## **PRELIMINARY BUILDING REGULATIONS REPORT**

**Address:** Renslade House, Exeter

**Description:** The construction of an 8 storey residential block for potential student accommodation.

**Drawings:** Mitchell Architects Drwg. No: 1953.P105, P104, P103, P102, P101, P100 including Jubb drwg H101, and outline briefs from acoustic, M&E and thermal design consultants.

## Diagram 52 Components of a firefighting shaft

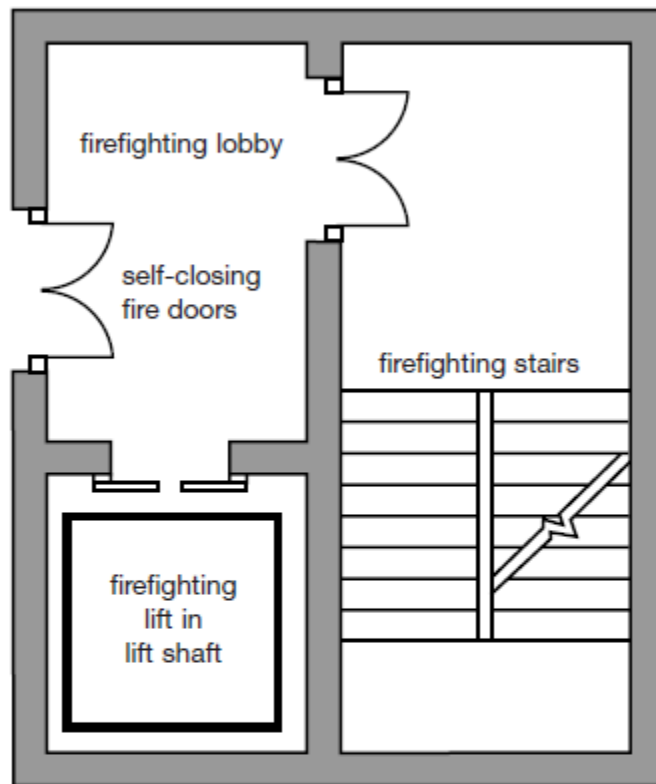
The fire fighting shaft details should be formed as follows;

The west core could be adapted by revising the layout to accommodate a fire fighting shaft configuration – it is noted that a dry riser is to be installed so again details on location and points of access will need to be submitted.

The proposals under this part are to be clarified as due to the height of the building exceeding 18m a firefighting shaft should be provided unless other fire suppressions systems are to be adopted please clarify and/ or revise the floors accordingly. The internal firefighting provisions for firefighting [dry riser] are to be further clarified and supported by detailed designs in due course.
